**Summary of Amendments to the Design Manual: Barrier Free Access 2008
(October 2020)**

Amendments to the Design Manual: Barrier Free Access 2008

(October 2020)

Figure 32A – Example of Braille and Tactile Plan of Toilet and Changing Room

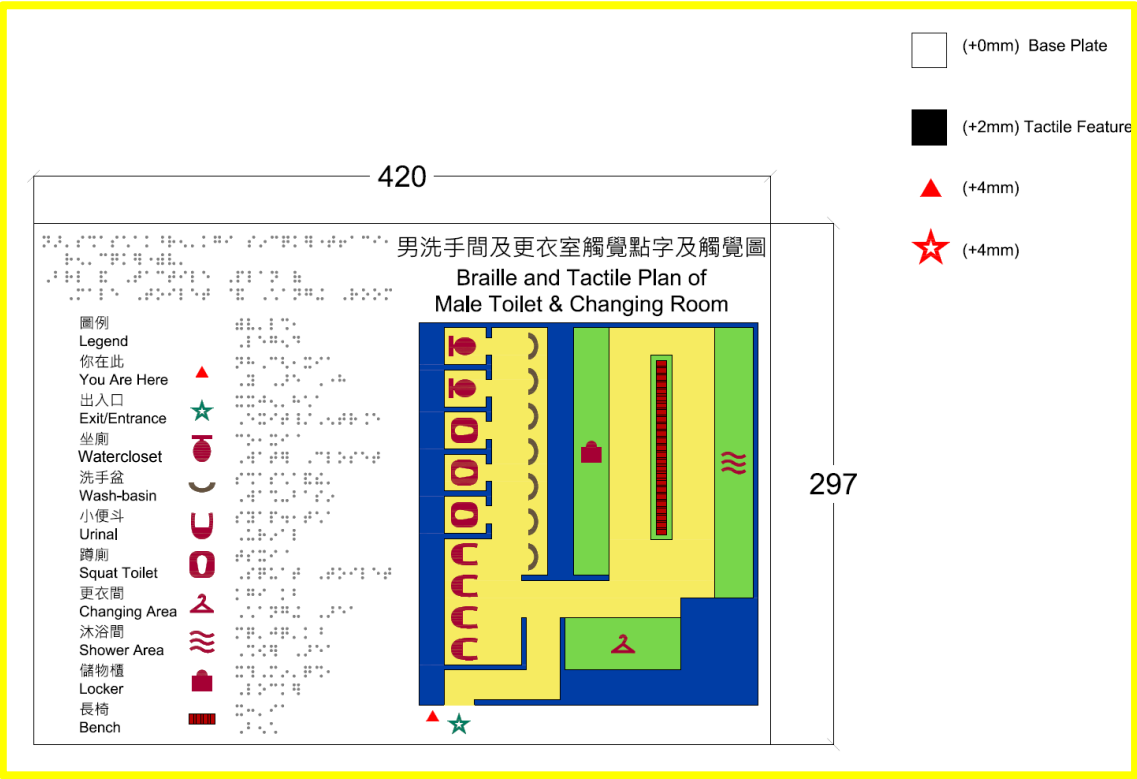
Item	2019 version	Amendments
<p>8. Division 13 of Chapter 4##*</p>	<p>BEST PRACTICE SECTION</p> <p>A. Design Considerations</p> <p>Persons with visual impairment may have difficulty in identifying their lockers for public use.</p> <p>B. Recommended Design Requirements</p> <p>Each locker door in sports complex, public swimming pool complex or public areas should be provided with Braille cells and raised Arabic numerals/characters*.</p> <p>* The locker key holders should be provided with raised Arabic numerals/characters.</p>	<p>BEST PRACTICE SECTION</p> <p>A. Design Considerations</p> <p>Persons with visual impairment may have difficulty in identifying their locker for public use, and sanitary fitments in a public toilet or changing room.</p> <p>B. Recommended Design Requirements</p> <p>(a) Each locker door in a sports complex, public swimming pool complex or public area should be provided with the locker number in Braille and raised Arabic numerals/characters*.</p> <p>* The locker key holders should be provided with raised Arabic numerals/characters.</p> <p>(b) A Braille and tactile plan (see Figure 32A) should be provided for the toilets with five or more waterclosets (urinal in a public male toilet and changing room is regarded as a watercloset for this purpose) in a public toilet/changing room. The plan should be installed on the wall adjacent to the door of the public toilet/changing room, or their entrance if entrance door is not provided. The plan should be placed at 900 mm to 1500 mm above the finished floor level.</p>

Item	2019 version	Amendments
		 <p data-bbox="965 480 1720 571">男洗手間及更衣室觸覺點字及觸覺圖 Braille and Tactile Plan of Male Toilet & Changing Room</p> <p data-bbox="1025 571 1344 997"> 圖例 Legend 你在此 You Are Here 出入口 Exit/Entrance 坐廁 Watercloset 洗手盆 Wash-basin 小便斗 Urinal 蹲廁 Squat Toilet 更衣間 Changing Area 沐浴間 Shower Area 儲物櫃 Locker 長椅 Bench </p> <p data-bbox="1854 284 2085 518"> □ (+0mm) Base Plate ■ (+2mm) Tactile Feature ▲ (+4mm) ★ (+4mm) </p> <p data-bbox="1323 416 1379 443">420</p> <p data-bbox="1753 722 1809 750">297</p>
